# ADA Curb Ramp New Construction Inspection Form (Perpendicular)

NW 292 st

23885.56

NW Keenon st

## PERPENDICULAR RAMP (PR)

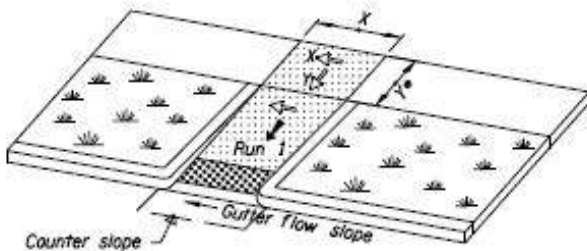
RR1 icrr (iitd not full width)
